INDIANA & MICHIGAN ELECTRIC COMPANY
DONALD C. COOK NUCLEAR PLANT

FACILITY CONCEPTUAL DESIGN DESCRIPTION
FOR THE
TECHNICAL SUPPORT CENTER AND THE EOF.

ATTACHMENT TO AEP:NRC:0531C

Attachment C to AEP:NRC:0745H
Responses to Questions on Unit 1 Cycle 8
Thermal Hydraulics (Non-Proprietary)

FIGURE 1 SCHEMATIC REPRESENTATION OF REACTOR CORE FINITE ELEMENT MODEL

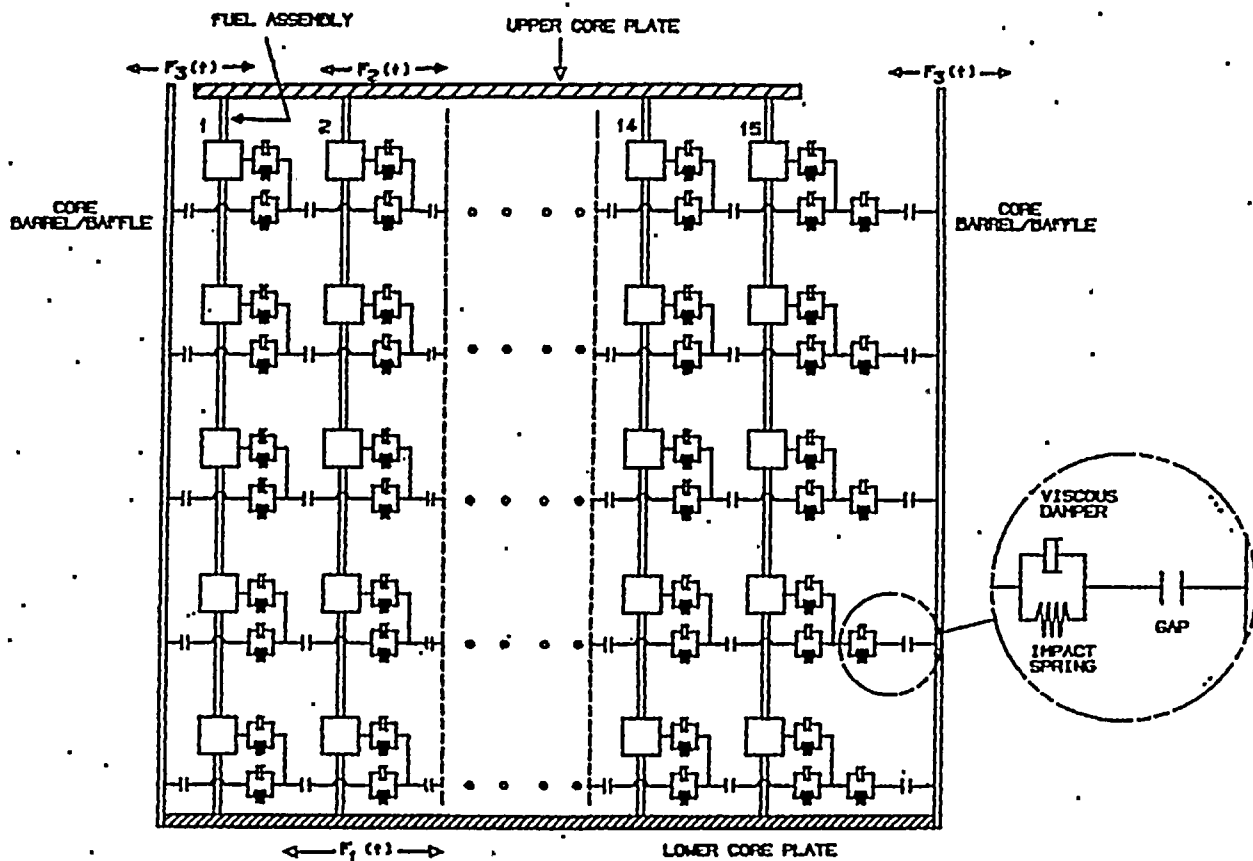
Q.3 Per the NRC SER cover letter on WCAP-9500, provide the following plant specific information:

- a) How was the rod bow penalty accounted for?
- b) Confirm that the predicted clad collapse time exceeds the expected lifetime of the fuel.
- c) Confirm that the appropriate seismic and LOCA forces on the fuel assemblies are within acceptable bounds.
- d) What are the fuel surveillance plans?

fifteen (15) fuel assemblies which correspond to the maximum number of assemblies across the core diameter were used in the model. The fuel assemblies are schematically represented by individual beam elements as shown in Figure 1. A spring and lumped mass system model consistent with the model described in Ref. (2) was used to represent the simplified fuel assembly elements in Figure 1. The discrete masses and spring rates were calculated directly from the fuel assembly frequencies and corresponding mode shapes. This type of model was adopted because it inherently provides an accurate representation of the fuel assembly higher natural frequencies and mode shapes.

The time history motion for the upper and lower core plates and the barrel at the upper core plate elevation are simultaneously applied to the simulated reactor core model as illustrated in Figure 1. The three time history motions were obtained from a time history analysis involving a finite element model of the reactor vessel and internals.
